AS CONSTRUCTED SEPTEMBER

NOT FOR CONSTRUCTION

CITY OF SANDY
WASTE WATER TREATMENT FACILITY
IMPROVEMENTS
SECONDARY CLARIFIER
MECHANICAL PIPING PLAN

3 WASTE PUMP STATION SECTION
 M20 SCALE: 1" = 1'-0"

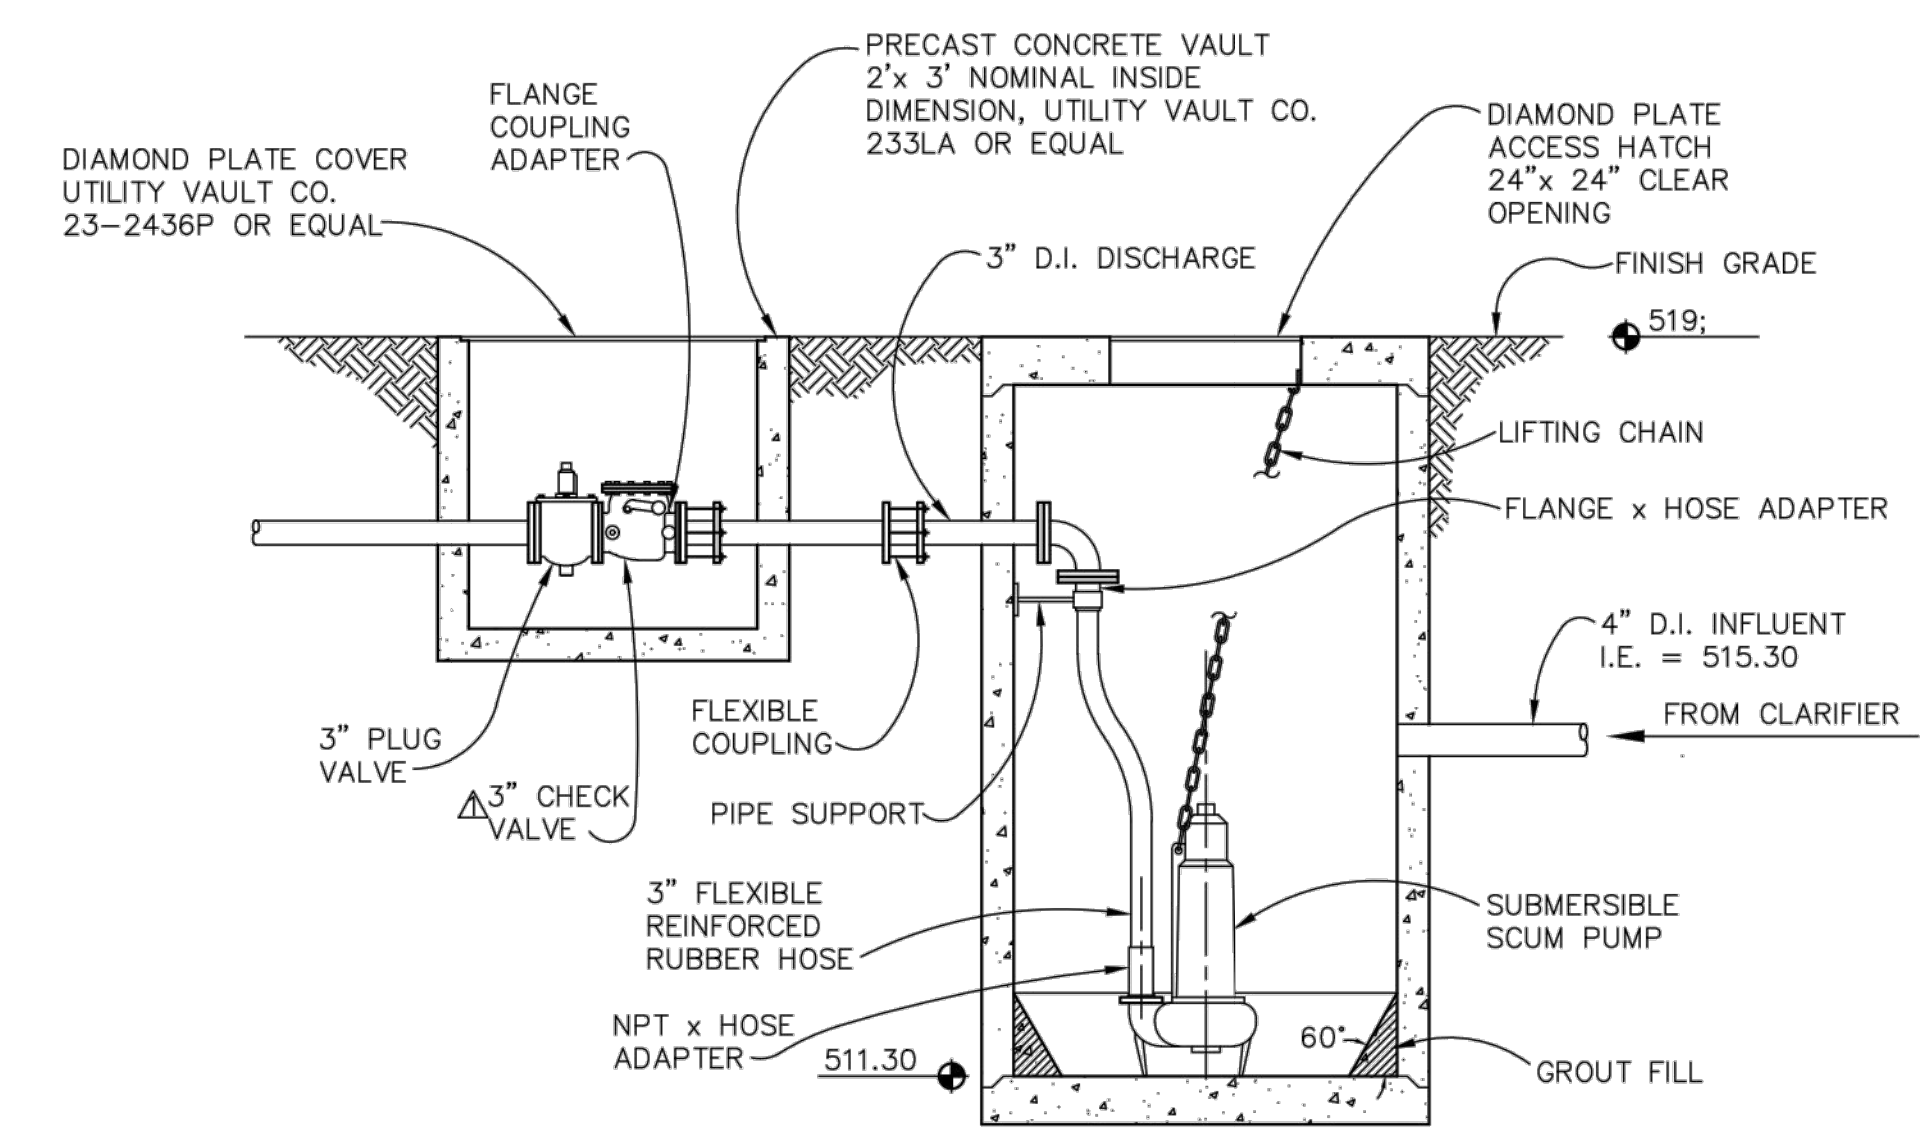
Install a new valve vault with new valves to accommodate the large pump discharge piping

Replace the pump discharge piping with larger piping to accommodate the larger pumps

Replace the existing submersible pumps with two new 650 gpm, 20 hp pumps with VFDs

EFFLUENT FILTRATION & DISINFECTION BASIN
PLAN
NOT TO SCALE

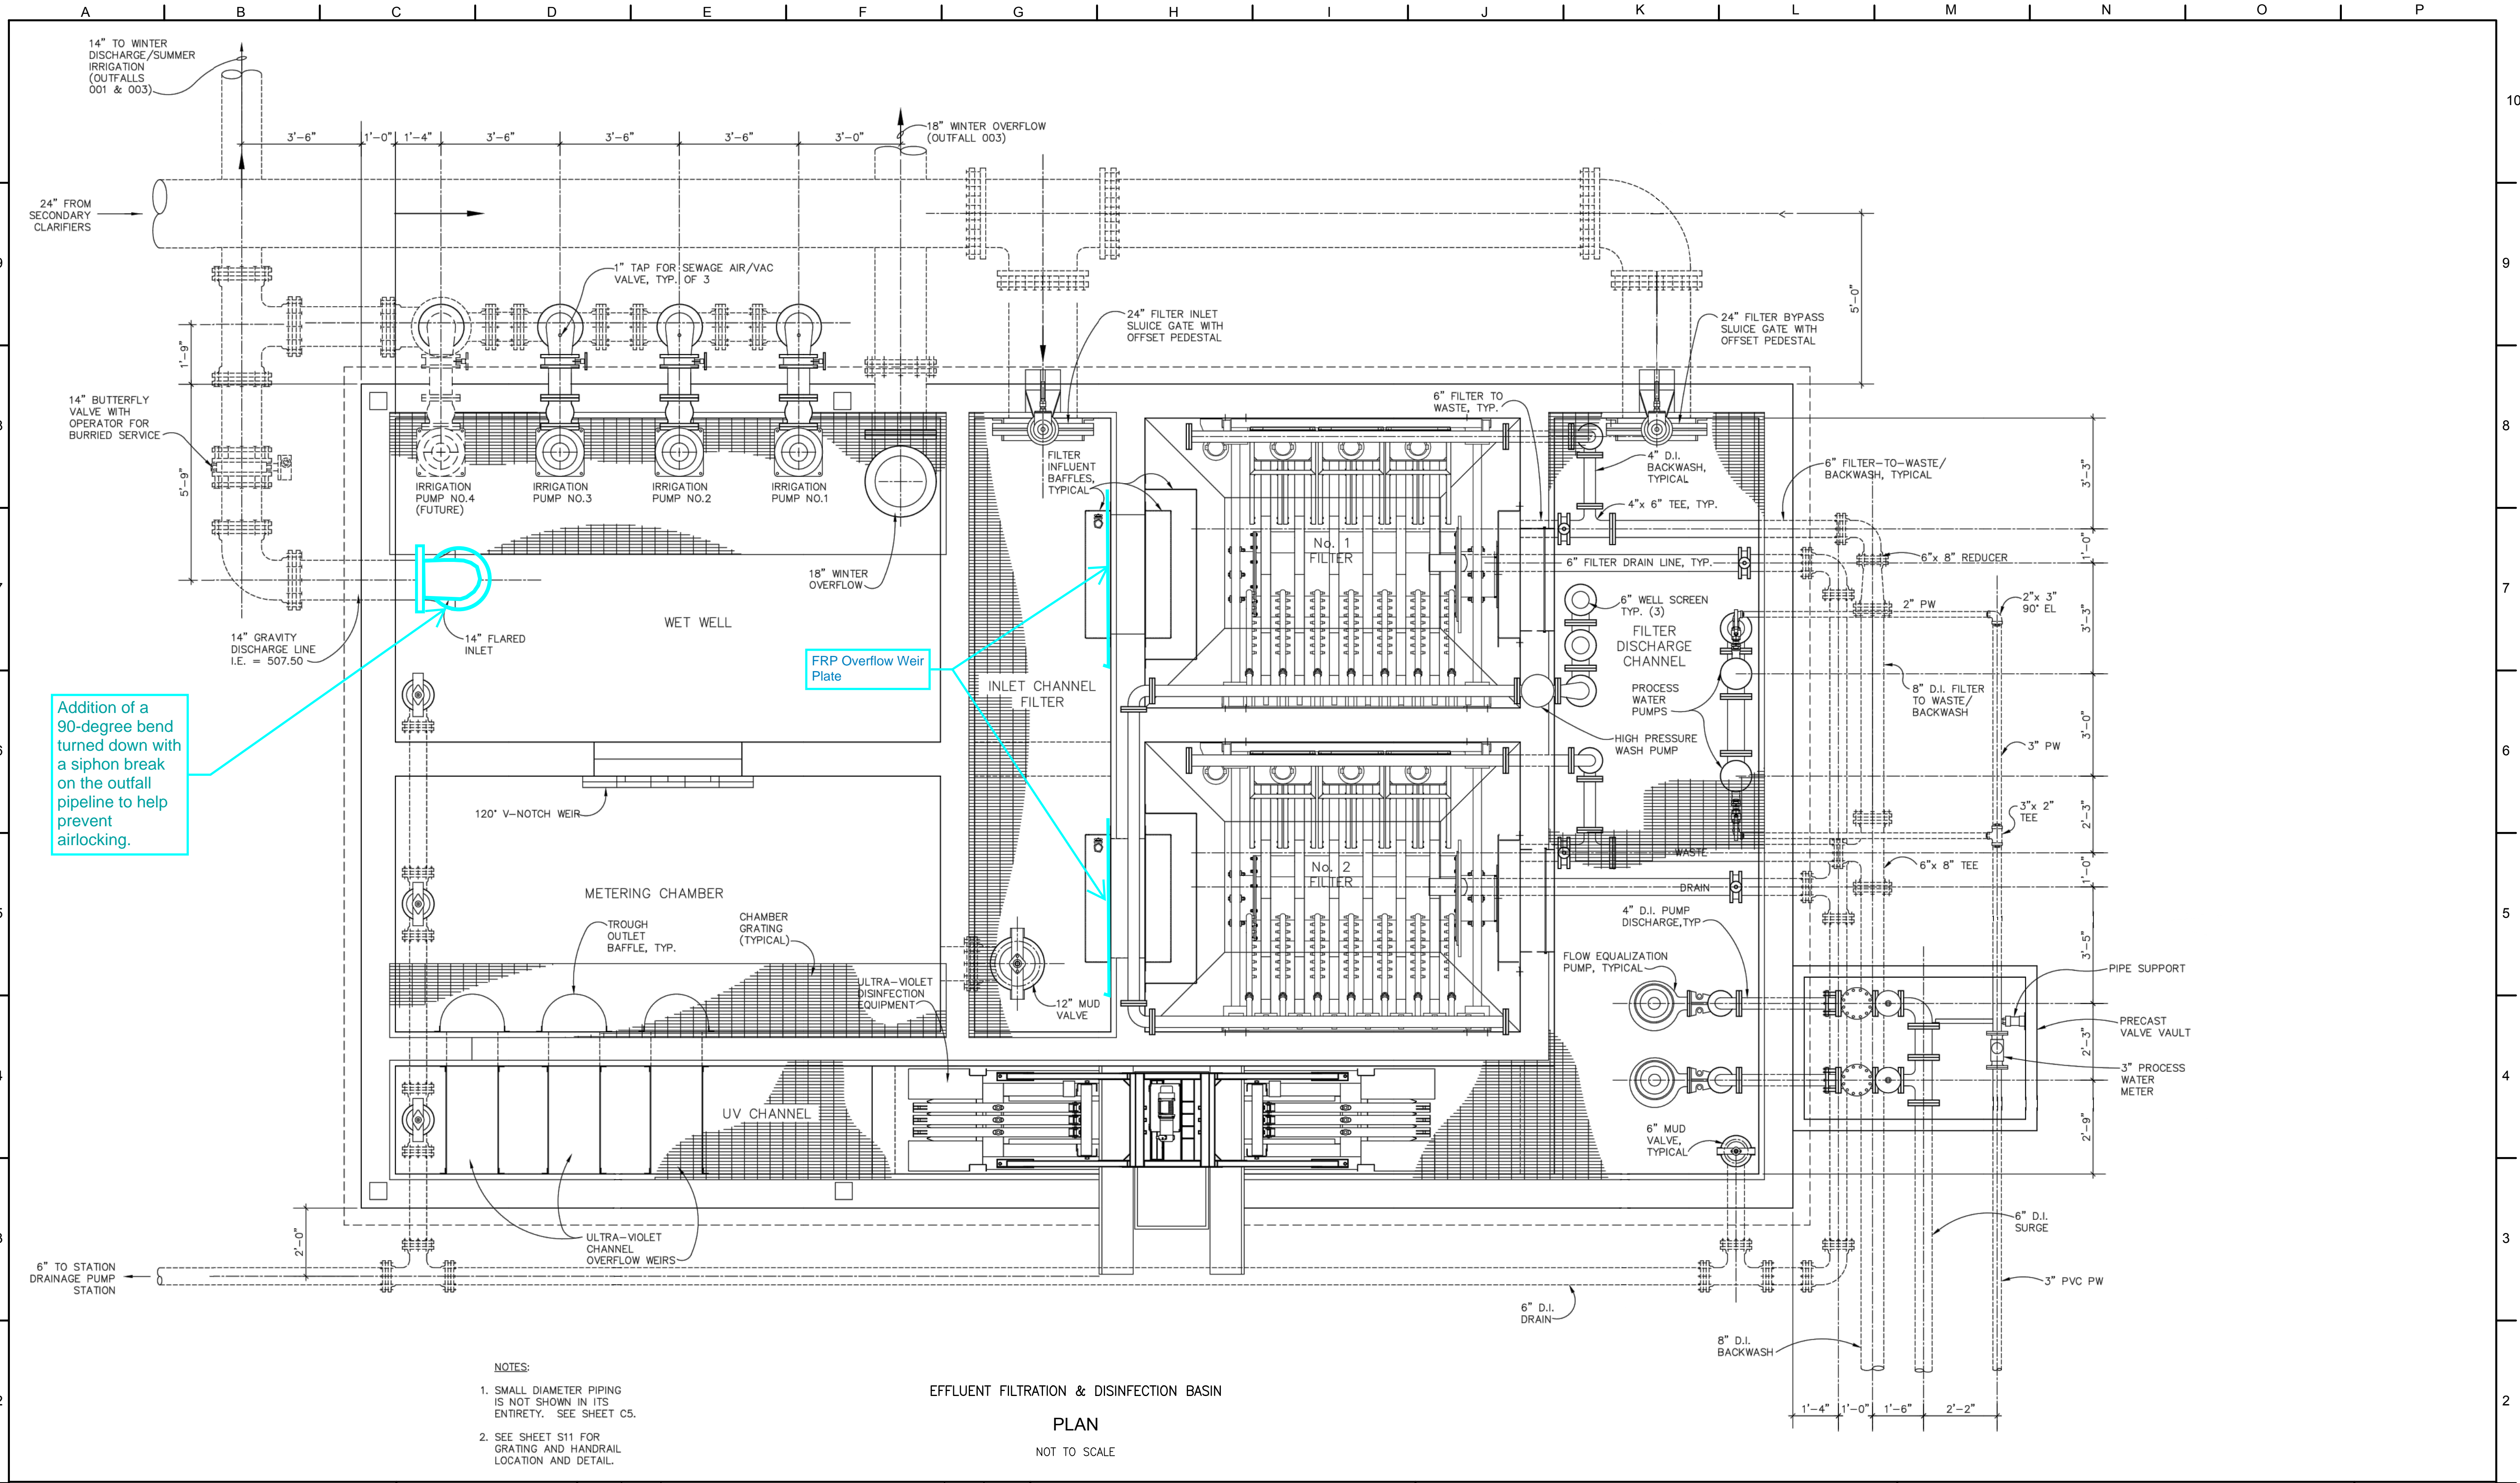
Addition of a 90-degree bend turned down with a siphon break on the outfall pipeline to help prevent airlocking.

CITY OF SANDY
WASTE WATER TREATMENT FACILITY
IMPROVEMENTS
480 VOLT, 3-PHASE
ONE LINE DIAGRAM

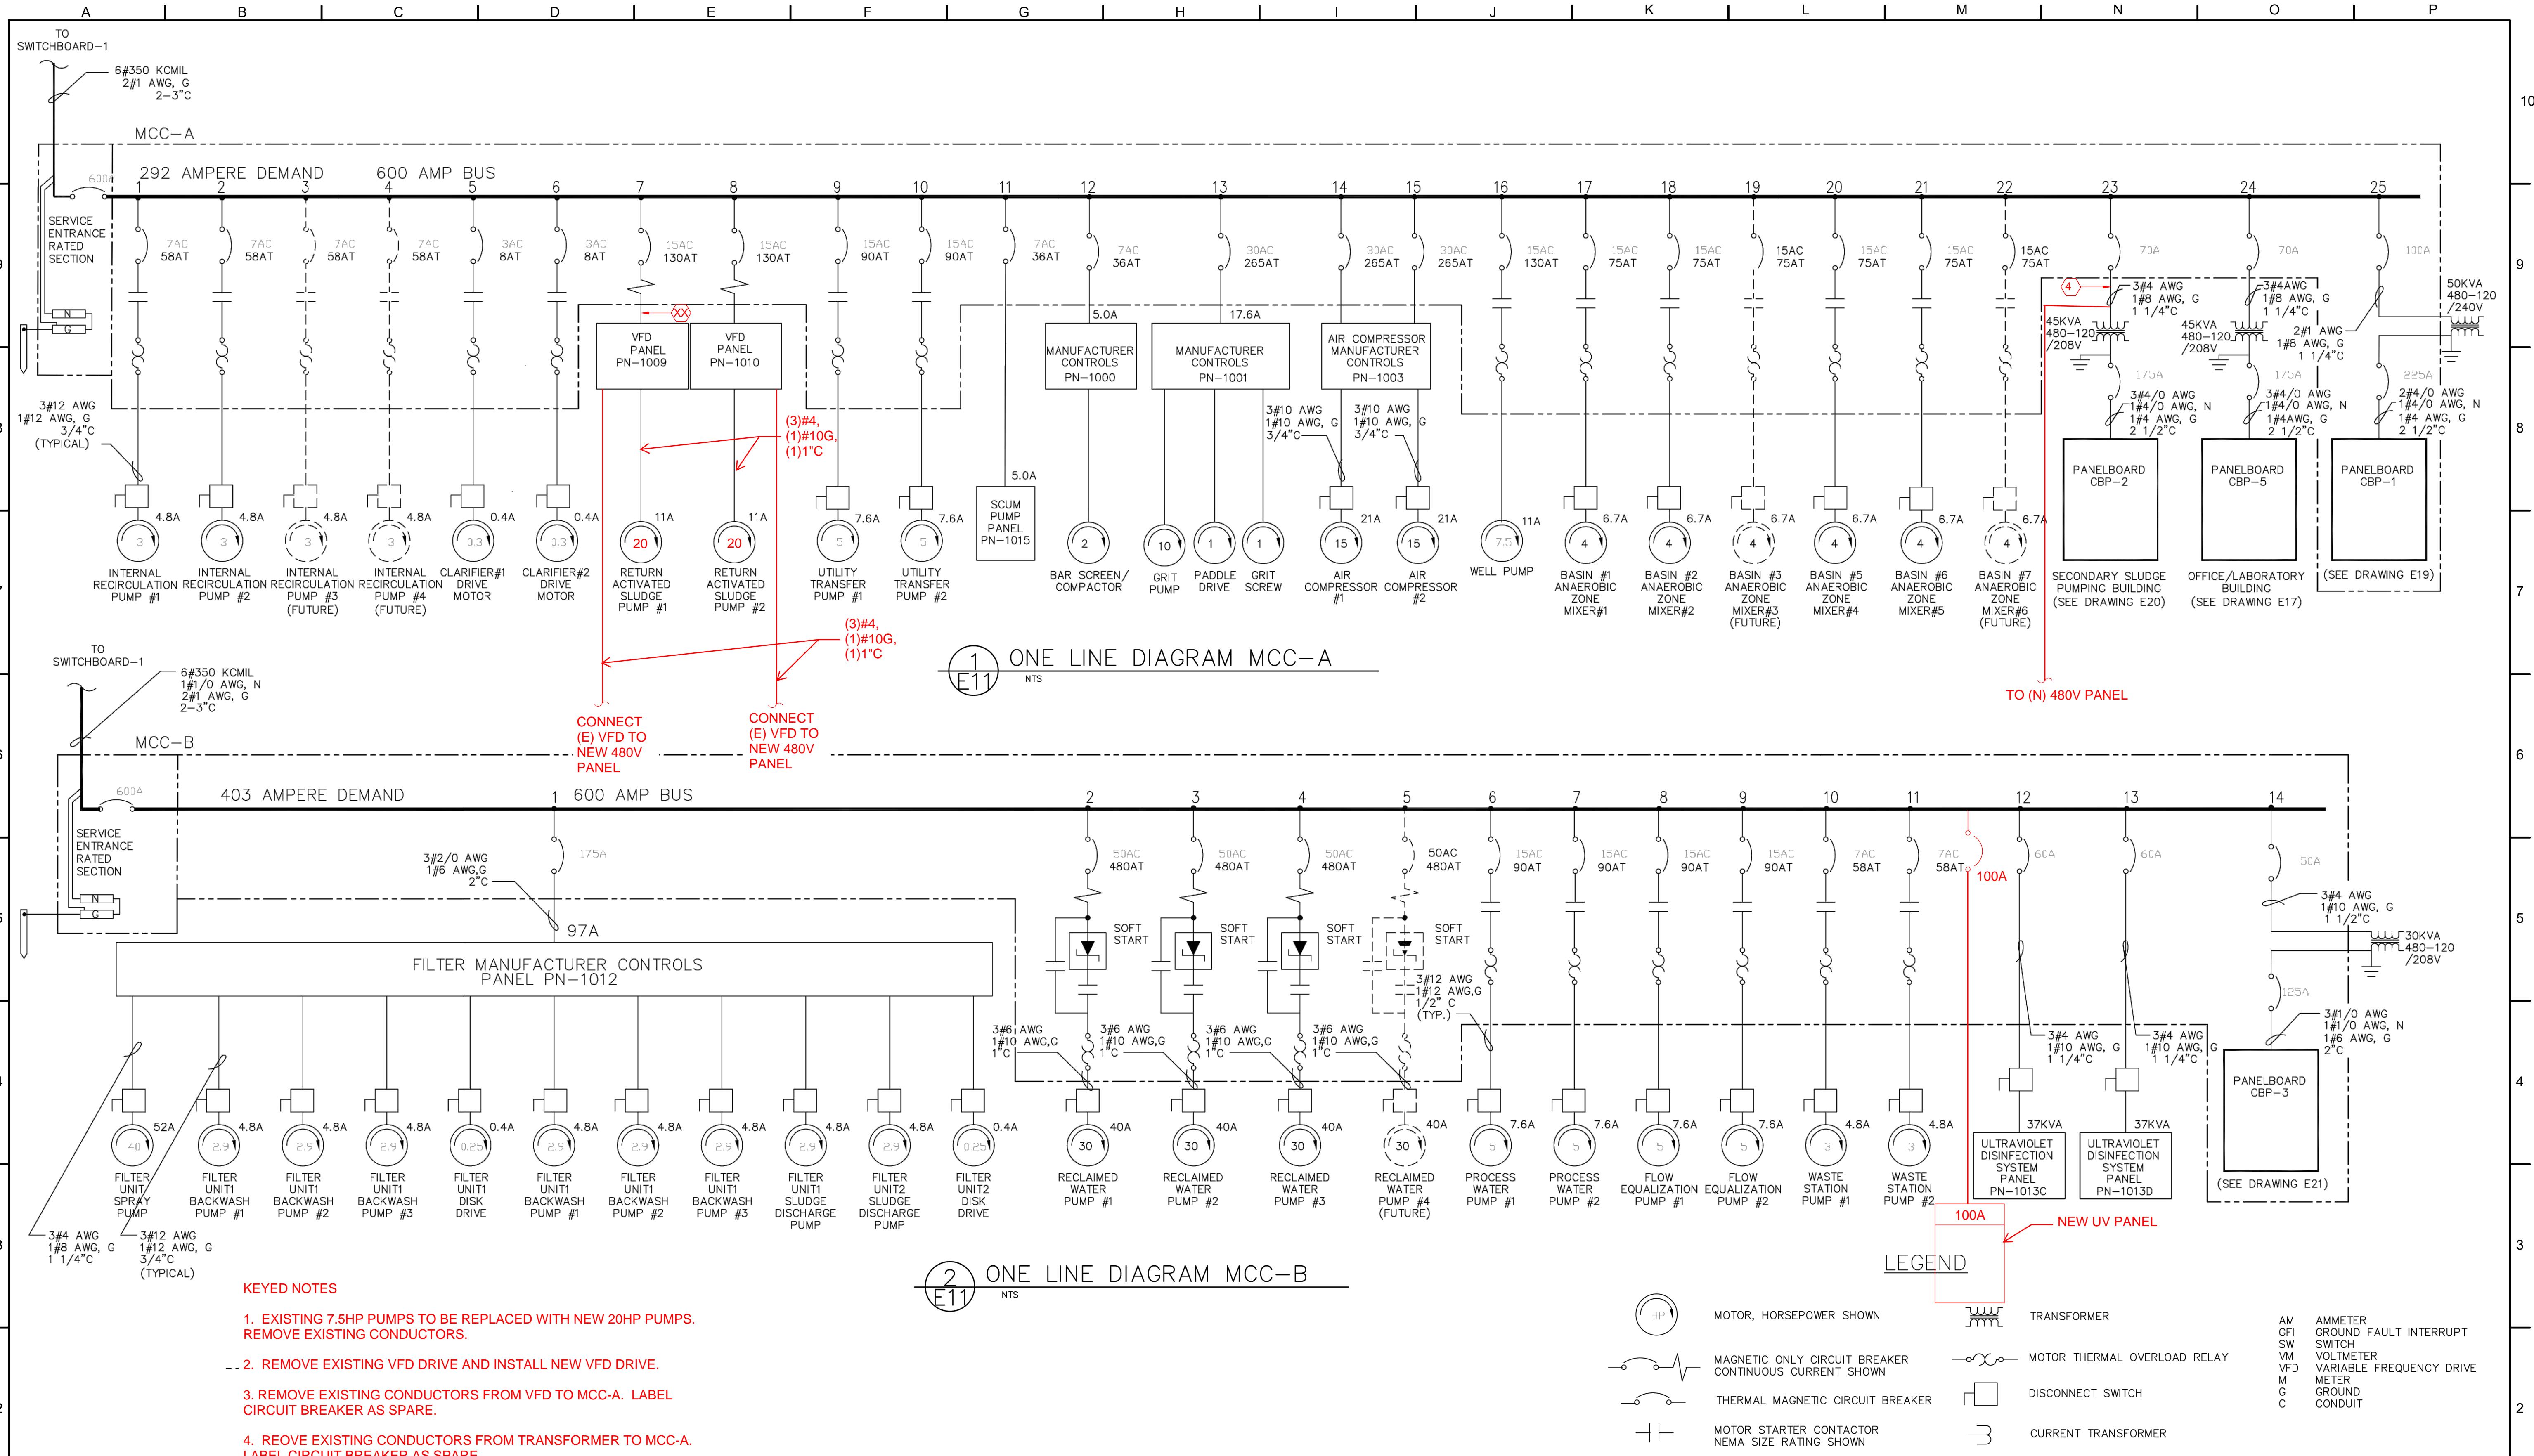
- KEYED NOTES**
- EXISTING 7.5HP PUMPS TO BE REPLACED WITH NEW 20HP PUMPS. REMOVE EXISTING CONDUCTORS.
 - REMOVE EXISTING VFD DRIVE AND INSTALL NEW VFD DRIVE.
 - REMOVE EXISTING CONDUCTORS FROM VFD TO MCC-A. LABEL CIRCUIT BREAKER AS SPARE.
 - REMOVE EXISTING CONDUCTORS FROM TRANSFORMER TO MCC-A. LABEL CIRCUIT BREAKER AS SPARE.
